Access Compliance Report

Public Rights-of-Way (Curb Ramps)

Intersection ID: 10990	Main Street: BARRINGTON_DR	Cross Street: LANECREST_DR	Location: NW
ADA ID: 85154E53C782	Ramp Type: Combination1	Initial Pass/Fail: Fail	Overall Compliance: No
Codes/Mitigation Info/Possible Solution		Field Measurements/Component Compliance

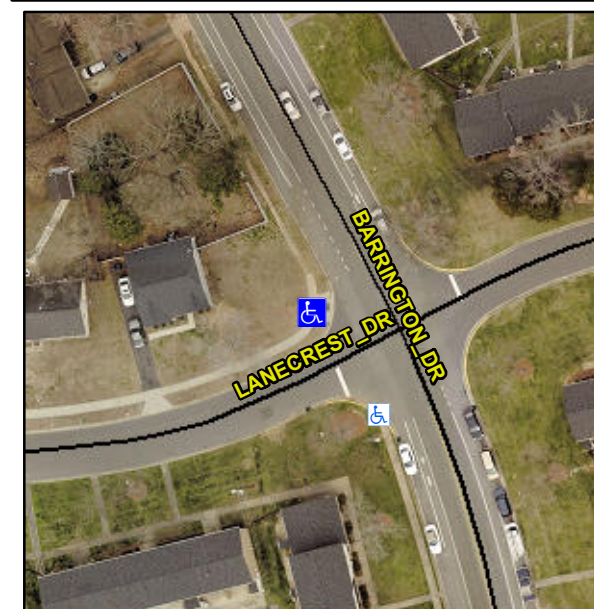
**Not Found, R304.5.1, R304.5.3,
R304.3.2**

Compliance	Description	Data	Compliance	Description	Data
N/A	Ramp Length LT (in)	48.0	N/A	Ramp Length RT (in)	50.0
Yes	Ramp Width LT (in)	48.0	Yes	Ramp Width RT (in)	48.0
No	Ramp Slope LT (%)	9.0	Yes	Ramp Slope RT (%)	6.0
No	Ramp XSlope LT (%)	4.6	No	Ramp XSlope RT (%)	5.1
N/A	Ramp Length (in)	72.0	Yes	Ramp Slope (%)	8.3
No	Ramp Width (in)	44.5	No	Ramp XSlope (%)	5.7
N/A	Flare Type LT	N/A	N/A	Flare Type RT	N/A
N/A	Flare Slope LT (%)	N/A	N/A	Flare Slope RT (%)	N/A
N/A	Flare Traversable LT?	N/A	N/A	Flare Traversable RT?	N/A
N/A	Landing Length (in)	N/A	N/A	DWS Provided?	N/A
N/A	Landing Width (in)	N/A	N/A	DWS Contrast?	N/A
N/A	Landing Slope (%)	N/A	N/A	DWS Length (in)	N/A
N/A	Landing X Slope (%)	N/A	N/A	DWS Full Width?	N/A
N/A	Landing Curb? (Y/N)	N/A	N/A	DWS Offset (in)	N/A
N/A	Shared Landing?	N/A			
N/A	Gutter Ponding?	N/A	N/A	Gutter Slope (%)	N/A
N/A	Gutter Lip Ht (in)	N/A	N/A	Gutter X Slope (%)	N/A
N/A	Painted X Walk1?	No	N/A	Painted X Walk2?	N/A

Remove & Replace Entire Ramp.
